RE: License SUB-1010; Docket No. 40-8027
Amendment Application
Revision to Part I, Chapters 2.0 and 5.0

BACKGROUND INFORMATION ON CHANGES REQUESTED

Figure 2-1

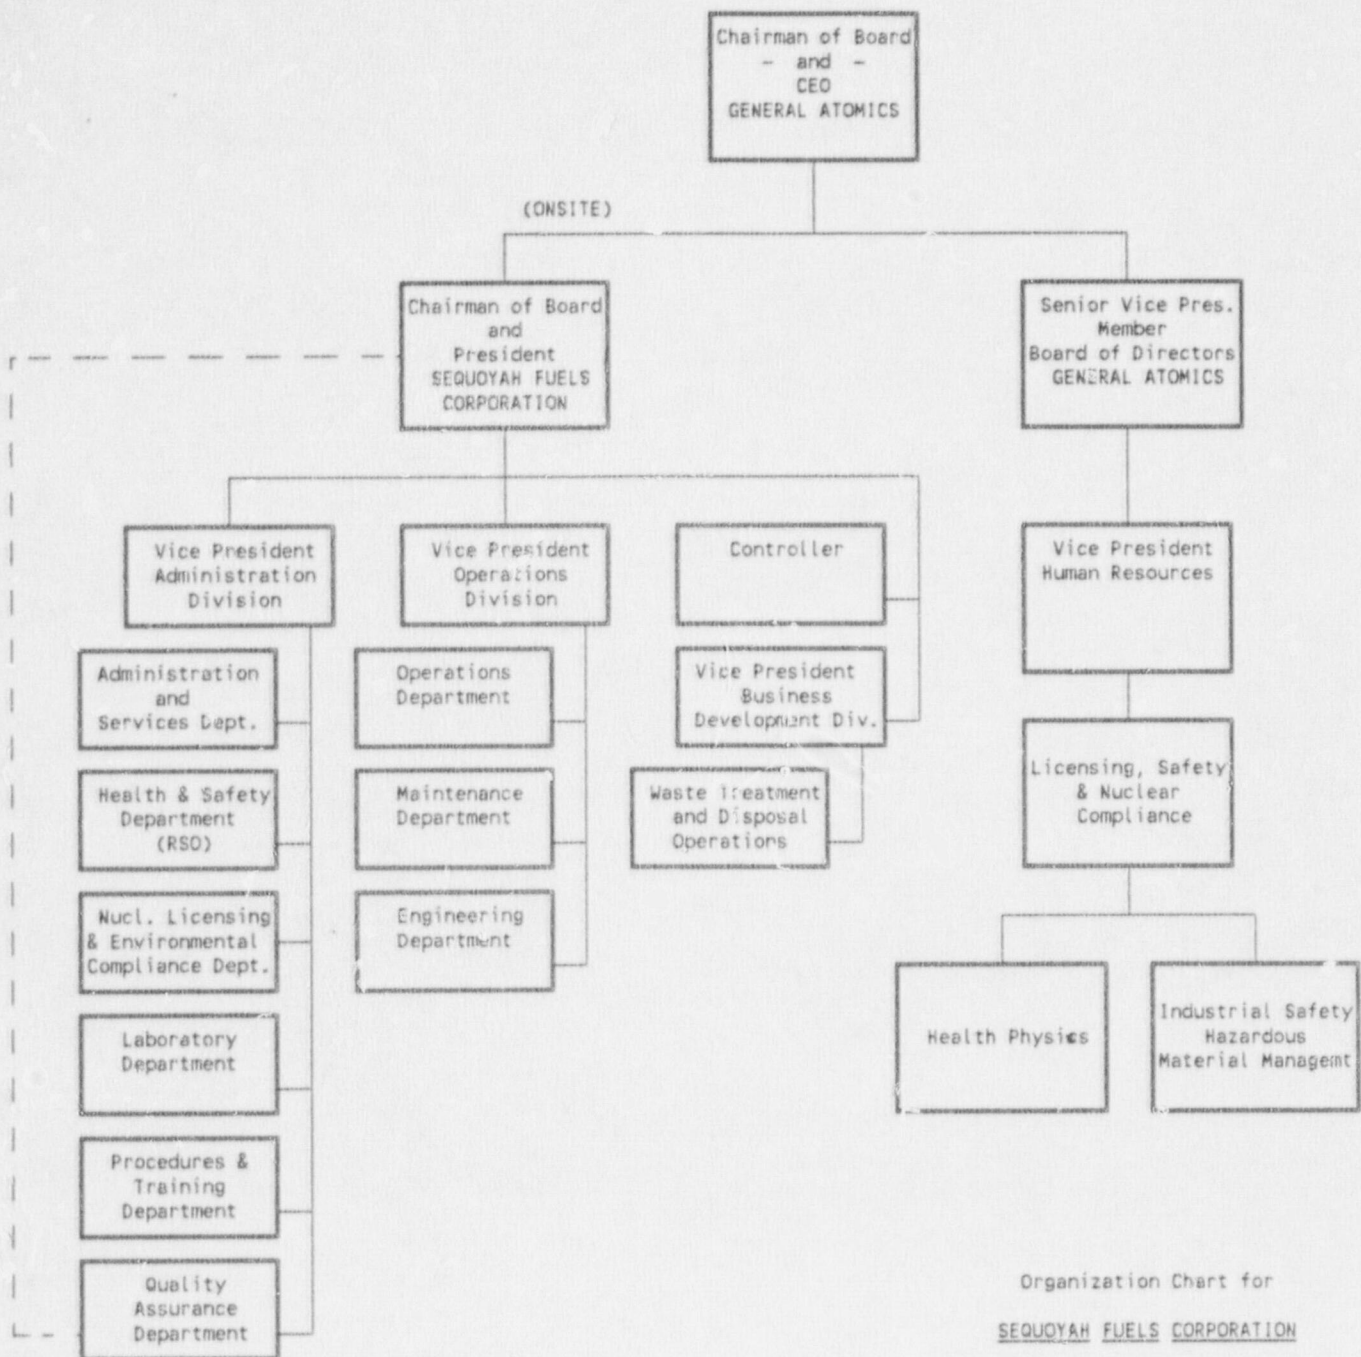
Figure 2.1: Add the Waste Treatment and Disposal Operations Department to the organization chart.
